Planning application for residential development south of Tilden Gill, Tenterden – Report on improvements to Junction of Ashford Road and Beacon Oak Road for Tenterden Town Council

Figure 6: View of BT Box with electricity facility on opposite side of A28 behind close boarded fence

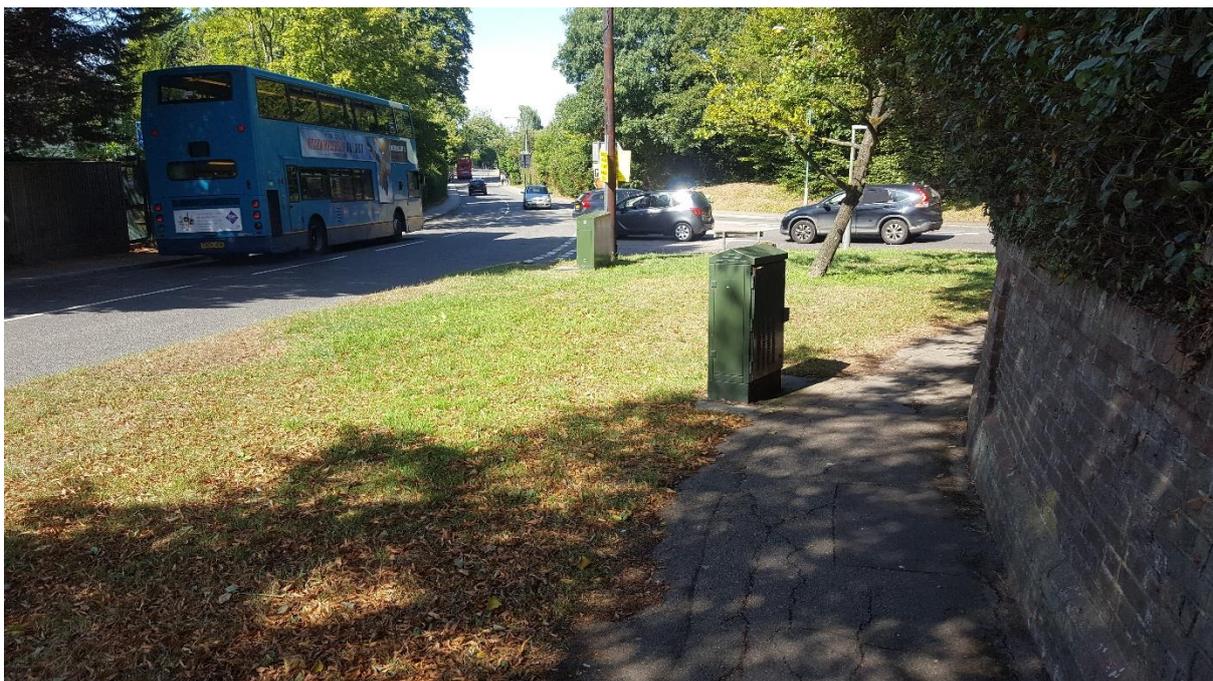
9. There are two green cabinets, see **Figure 7**, in the eastern verge of Ashford Road at the junction, the one closest to the kerb line, see **Figure 6**, being the aforementioned BT box and the other an electricity box. On the opposite side of Ashford Road at the junction there is another larger electricity installation, owned by UK Power Networks, within a locked enclosure which prevents widening on the western side of the road.
